CITY OF PORTLAND, MAINE

Project Name: 23 Ocean Avenue Mixed Use
Address: 23 Ocean Avenue
Applicant: 23 Ocean Avenue Associates, LLC
Planner: Nell Donaldson

PLANNING BOARD REPORT PORTLAND, MAINE

Mixed-Use Development
23 Ocean Avenue
Level III Site Plan and Subdivision Review
23 Ocean Avenue Association, LLC

Figure 5:
Proposed
off-site
parking at
28 Vannah
Avenue, with
missing
sidewalk link
highlighted.

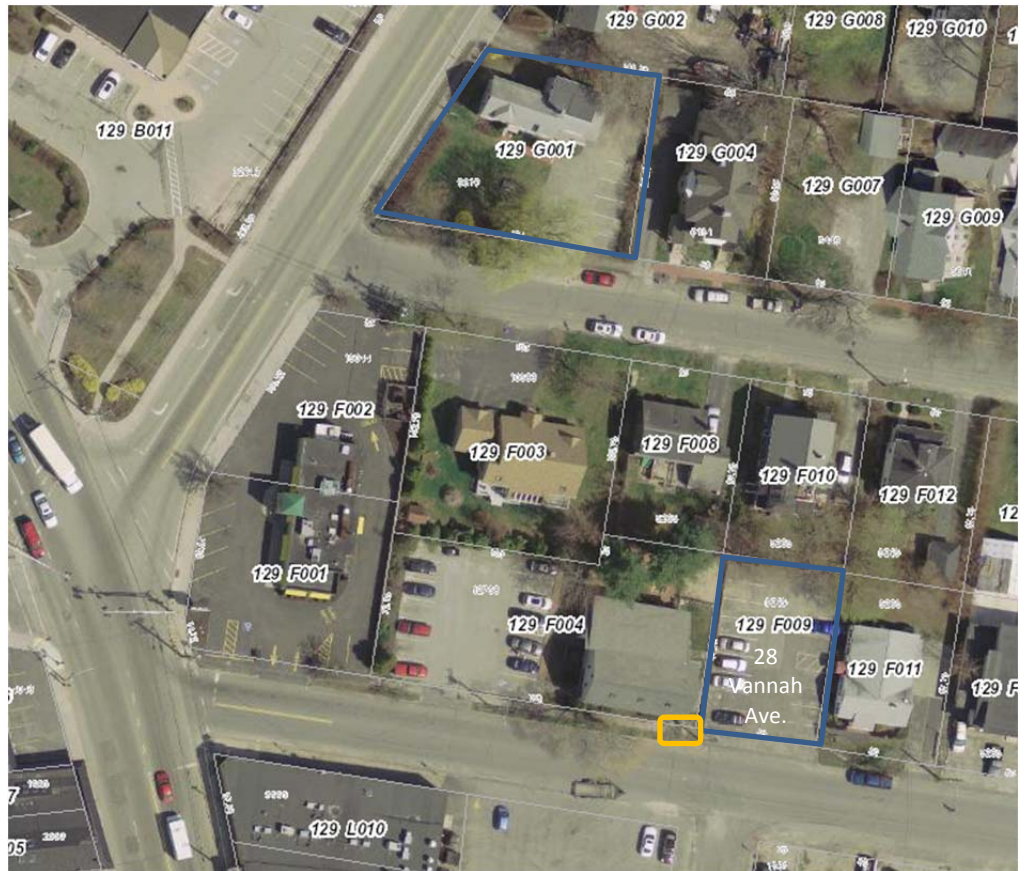
I support the location of the offsite parking lot on Vannah Avenue. For it to be fully accessible by pedestrians to and from the site, the applicant shall construct a missing sidewalk section on the north side of Vannah Avenue near the proposed parking lot. The applicant shall submit plans to the City for review and approval.

4. Prior to certificate of occupancy, the applicant shall submit final details for the reconstruction of the missing sidewalk link on the north side of Vannah Street between the proposed off-site parking and the site and construct this sidewalk segment for review and approval by the Department of Public Works;
